| <b>Document Title</b>                    | <b>INVESTIGATION INTO THE UNCONTROLLED RELEASE OF HYDROCARBONS FROM THE MONTARA WELLHEAD PLATFORM ON THE 21 AUGUST 2009 – EXPERT WITNESS REPORT</b> |
| <b>SW Doc Ref.</b>                       | <b>RPT-30291-NOPSA-001 VOLUME 2</b>   |
| <b>Date</b>                              | <b>17 February 2012</b>   |

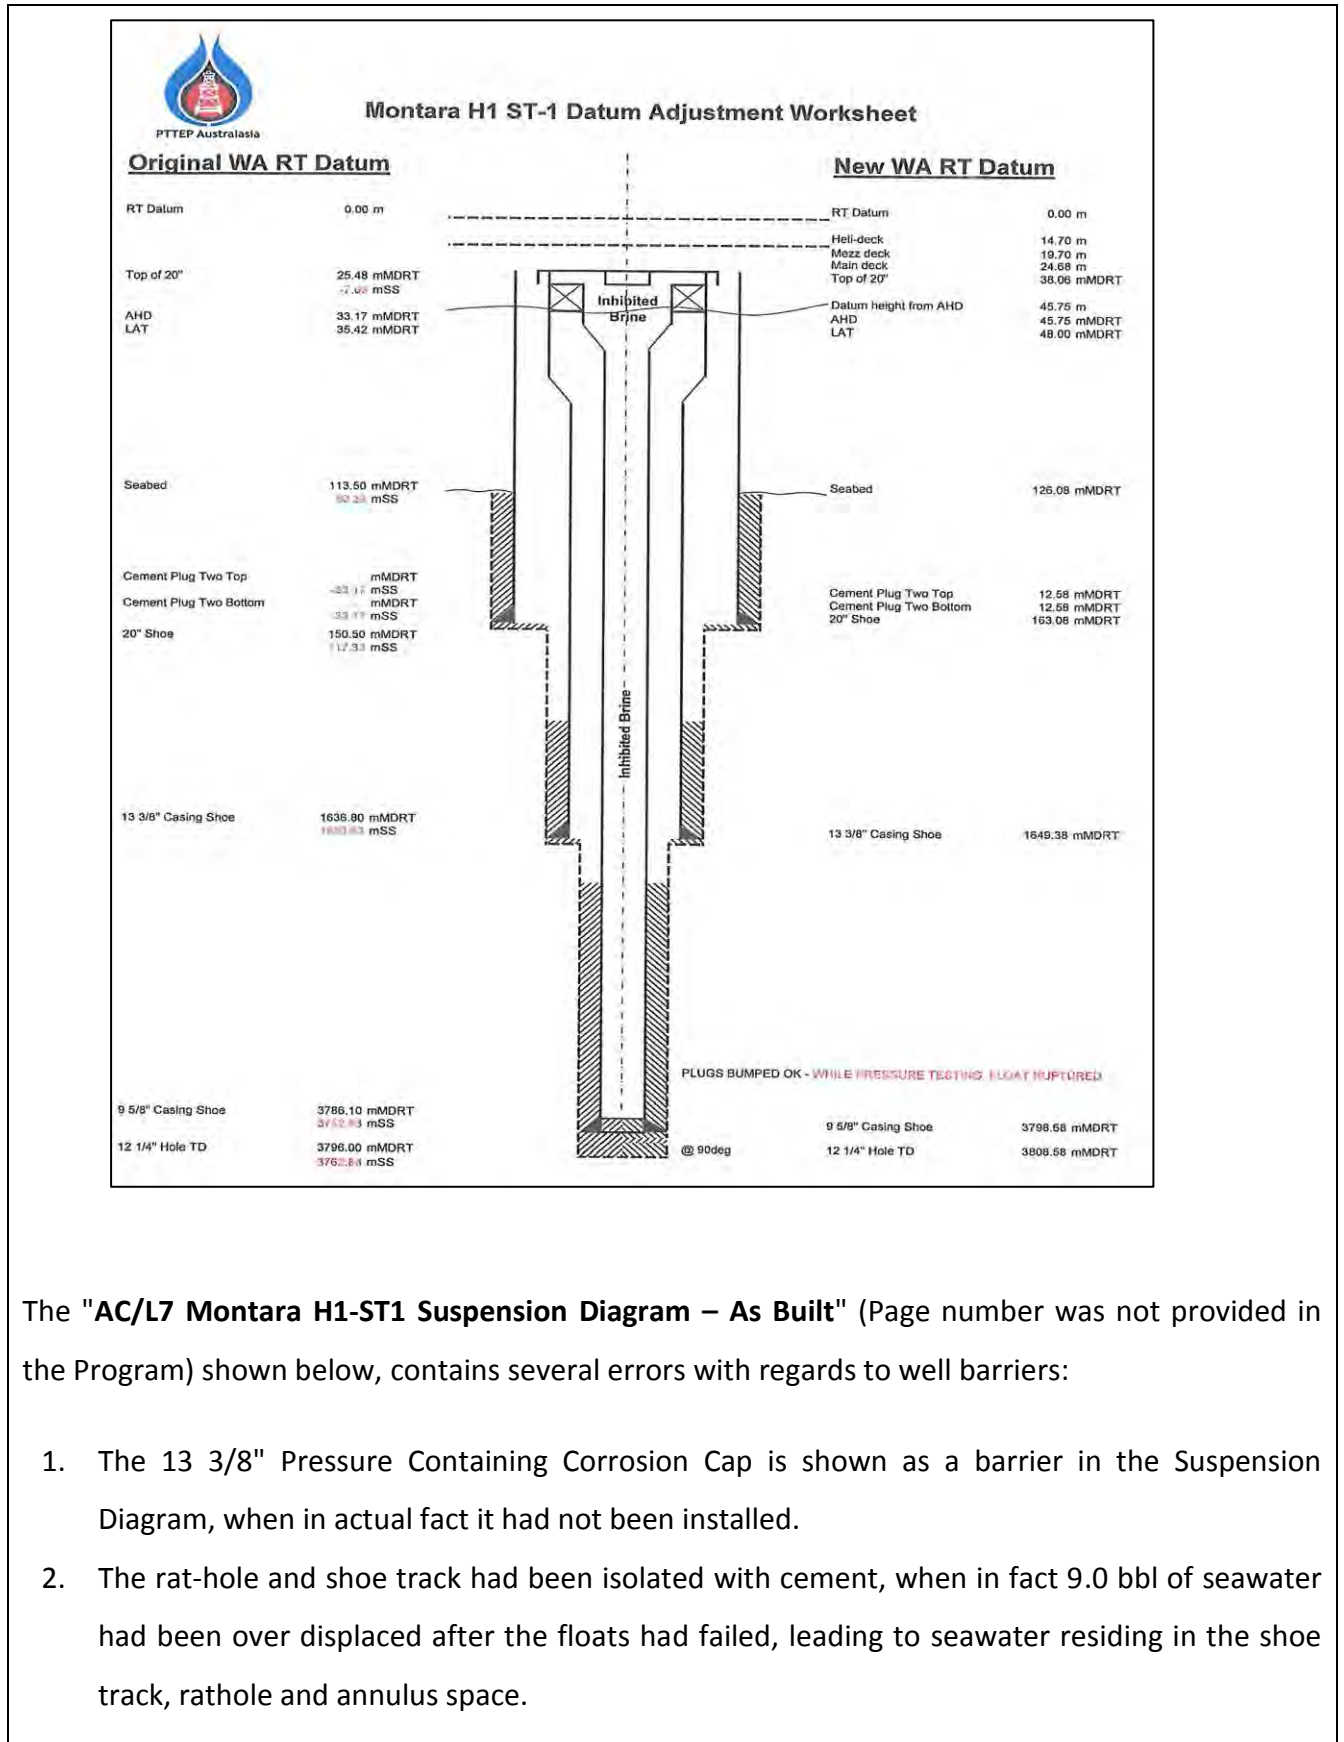
*"Hazard - Gas below the TA Cap*

*Consequence - Gas to surface without BOP's in place*

*Prevention/ Mitigation - Sting into the cap and record any pressure. **Bleed-off any pressure below the cap before removing the cap**".*

The "AC/L7 Montara H1-ST1 Suspension Diagram – As Built" (Page number was not provided in the Program) shown below, contains several errors with regards to well barriers:

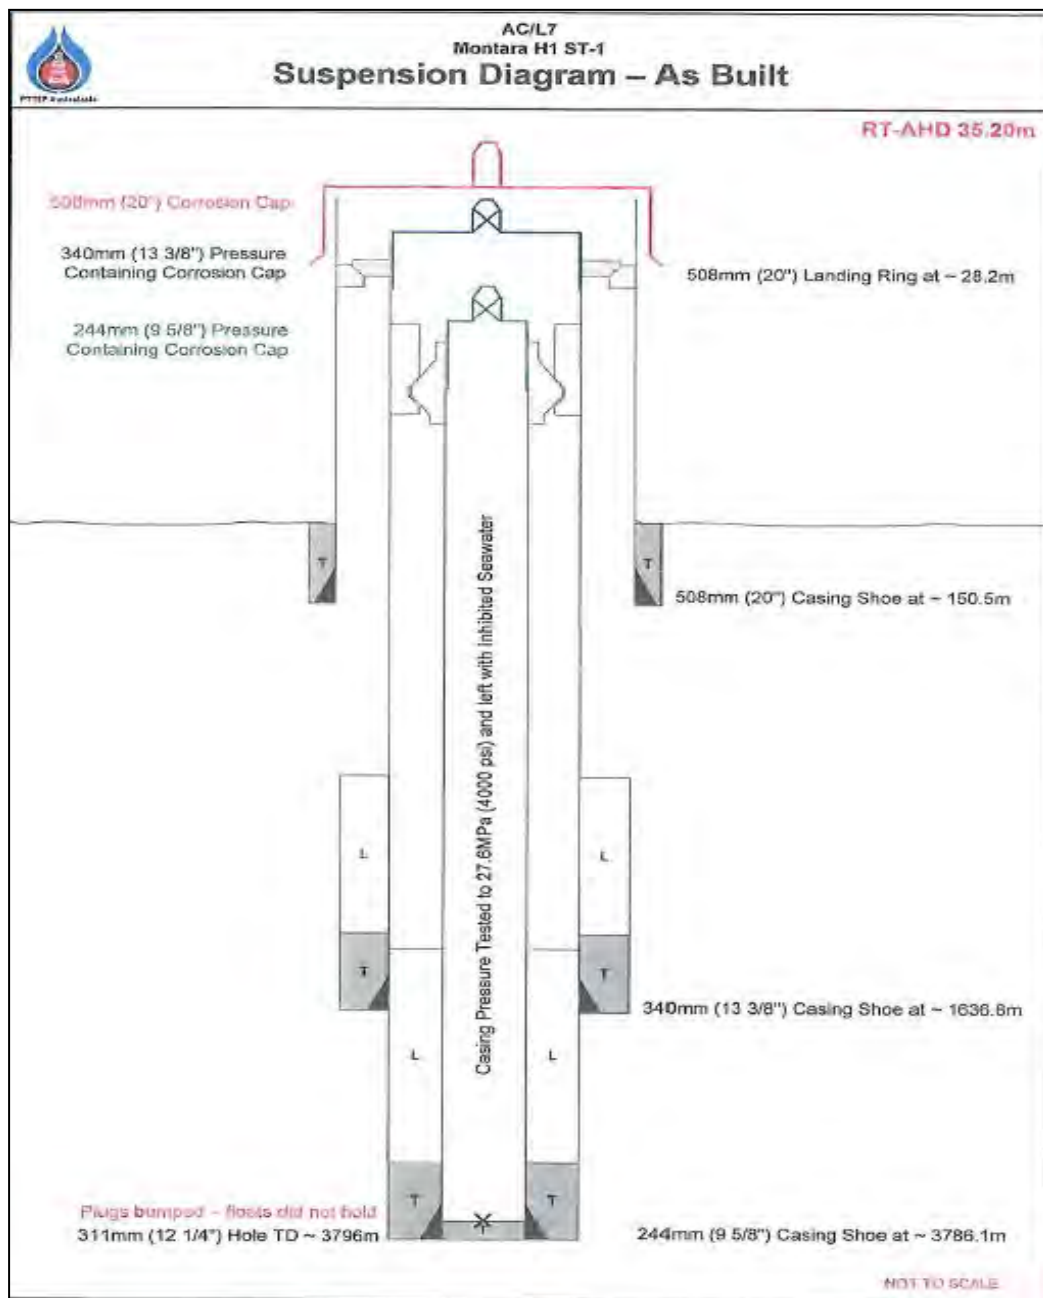
1. The 13 3/8" Pressure Containing Corrosion Cap is shown as a barrier in the Suspension Diagram, when in actual fact it had not been installed.
2. The rat-hole and shoe track had been isolated with cement, when in fact 9.0 bbl of seawater had been over displaced after the floats had failed, leading to seawater residing in the shoe track, rathole and annulus space.
